Felling in the Purasawpa rala in the Kegalle City

Filling in the Purnayya's Nala in the Nagpore City.

SUBJECT
Submits for Sanction two estimates with plans in duplicate in connection with the filling up of the Puniah's Nalla, Mysore City

Abstract estimate for filling the Purnaki Nala on Rockight Pleco Station to 5" W pipe line along buried in continuation of Rajpipat wall road.

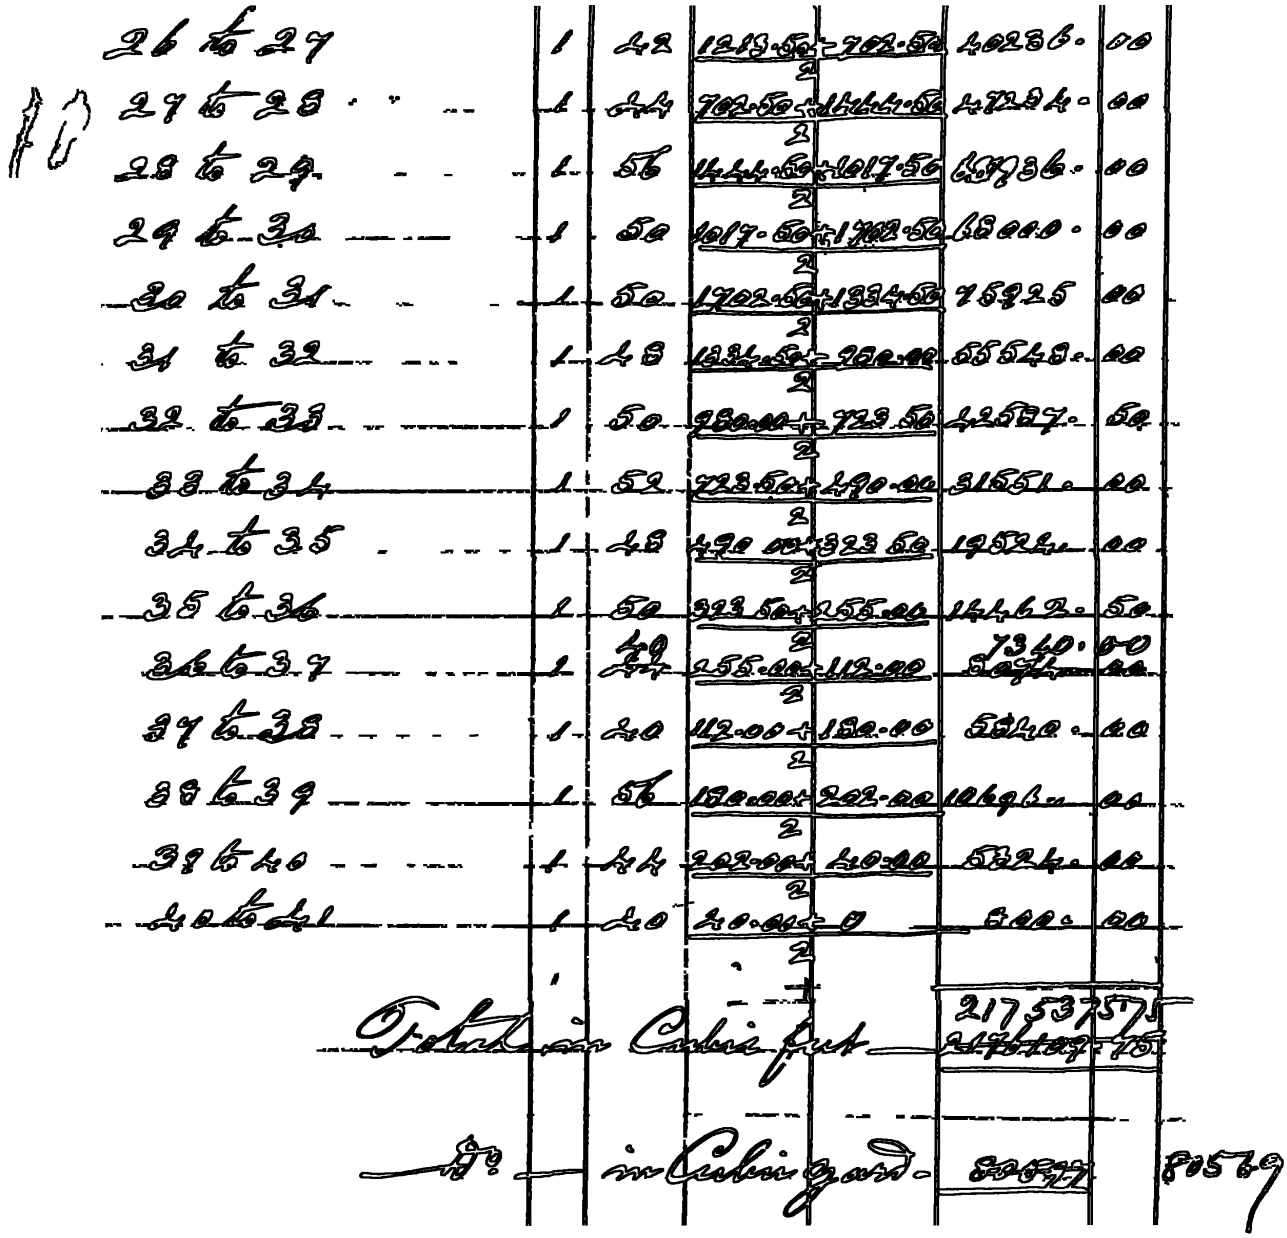
5. The estimates received with the reference are returned duly checked, the big estimate for filling up the Purnaiyya's Nala has been corrected from Rs 49,725/ to Rs 51,436/- The other estimate is correct. Separate reports explaining provision in the estimates should have been submitted, but in this instance the necessity for the proposals is explained in the covering letter by the Chairman

Items of work	Rate	Quantity	Rs
Quantity required for filling the Purnaiah Nalla to the ground level	cft.	251243 ~~2,44,719~~	
Quantity available on the eastern side of the Nalla	cft.	30017 ~~29,955~~	
Quantity available on the western side of the Nalla	cft.	80569 ~~80,571~~	
Total quantity available	cft. @ 2 a	110586 ~~110582~~	13823
Balance required for filling the Nallah	cft. @ 4 a	140657 ~~1,34,787~~	35164 ~~33534~~
Total Rupees			48957 ~~47357~~
Contingencies at 5 per cent			2449 ~~2368~~
Grand total Rupees			51436 ~~49725~~
